MODIFICATION RECOMMENDED

# DSOX3052A-01

## S E R V I C E N O T E

DSOX3052A – Oscilloscope, Mixed Signal, 2 Channel,  
500MHz

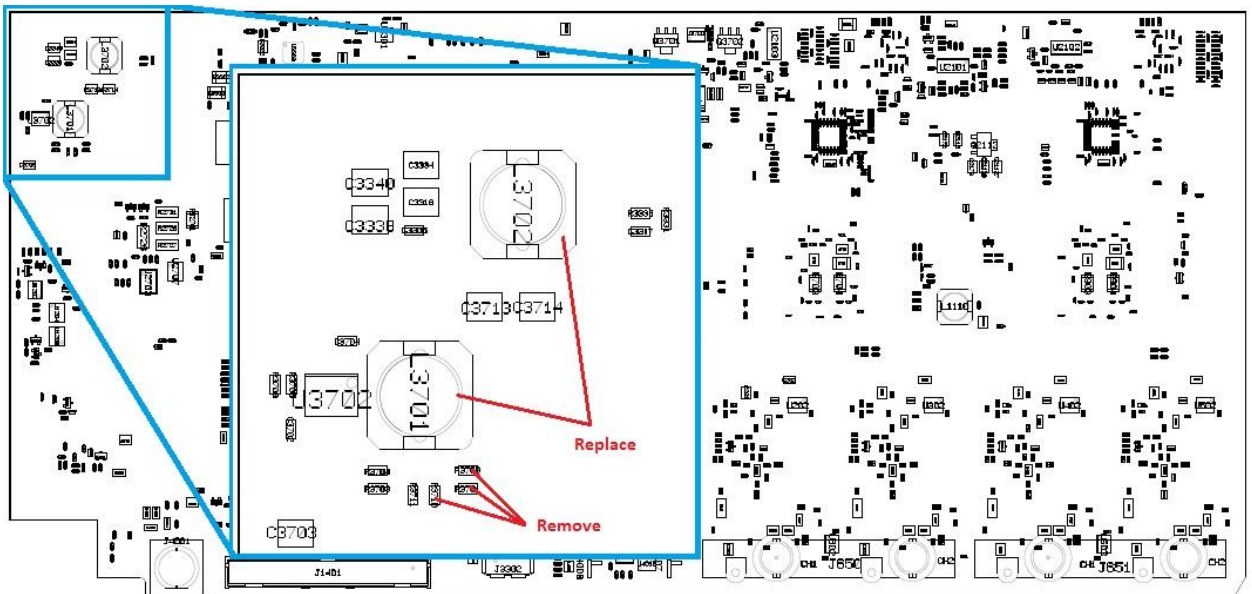
With the oscilloscope power turned on and while under normal operation, the unit emits a hissing noise.

1. Follow the procedure to remove the acquisition board for the X3000 as in the Agilent 2000/3000 X-Series Oscilloscopes Service Guide (<http://cp.literature.agilent.com/litweb/pdf/75019-97039.pdf>), pp. 117-121, until you make a visual to the following components:

2. As the picture indicates, remove the three resistors (0699-7209, 1 Ohm) located at R3701, R3709, and R3710. They are not to be replaced.
3. Remove as well the two inductors (9140-6474, 100uH) located at L3701 and L3702 and replace them with inductors with part number 9140-6151 (68 uH).
4. Re-assemble to the point where the unit could be powered up to verify that the hissing is indeed gone. If the hissing is not gone, please, check modifications.
5. When the hissing is gone, put oscilloscope back together.
